Access Compliance Report

Public Rights-of-Way

(Curb Ramps)

Intersection ID: 12274	Main Street: BERRYHILL_RD	Cross Street: MORTON_ST	Location: SE
ADA ID: BD1A789E2109	Ramp Type: Combination1	Initial Pass/Fail: Fail	Overall Compliance: No
Severity Score: 47.5			
Codes/Mitigation Info/Possible Solution		Field Measurements/Component Compliance

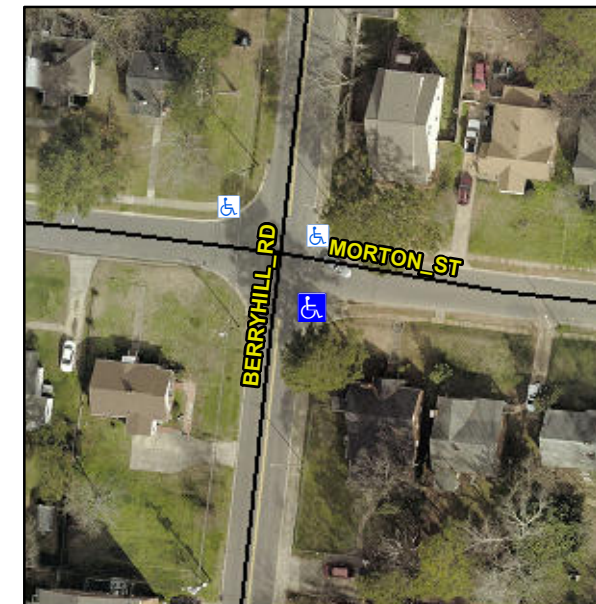
LT RP < 5%

Not Found, R304.5.1, R304.5.1, R304.5.3

Compliance	Description	Data	Compliance	Description	Data
N/A	Ramp Length LT (in)	94.0	N/A	Ramp Length RT (in)	56.5
No	Ramp Width LT (in)	41.0	Yes	Ramp Width RT (in)	96.0
Yes	Ramp Slope LT (%)	2.1	Yes	Ramp Slope RT (%)	7.2
No	Ramp XSlope LT (%)	5.1	No	Ramp XSlope RT (%)	5.6
N/A	Ramp Length (in)	94.0	Yes	Ramp Slope (%)	6.7
No	Ramp Width (in)	26.0	No	Ramp XSlope (%)	2.1
N/A	Flare Type LT	N/A	N/A	Flare Type RT	N/A
N/A	Flare Slope LT (%)	N/A	N/A	Flare Slope RT (%)	N/A
N/A	Flare Traversable LT?	N/A	N/A	Flare Traversable RT?	N/A
N/A	Landing Length (in)	N/A	N/A	DWS Provided?	N/A
N/A	Landing Width (in)	N/A	N/A	DWS Contrast?	N/A
N/A	Landing Slope (%)	N/A	N/A	DWS Length (in)	N/A
N/A	Landing X Slope (%)	N/A	N/A	DWS Full Width?	N/A
N/A	Landing Curb? (Y/N)	N/A	N/A	DWS Offset (in)	N/A
N/A	Shared Landing?	N/A			
N/A	Gutter Ponding?	N/A	N/A	Gutter Slope (%)	N/A
N/A	Gutter Lip Ht (in)	N/A	N/A	Gutter X Slope (%)	N/A
N/A	Painted X Walk1?	No	N/A	Painted X Walk2?	N/A

Remove & Replace Entire Ramp.
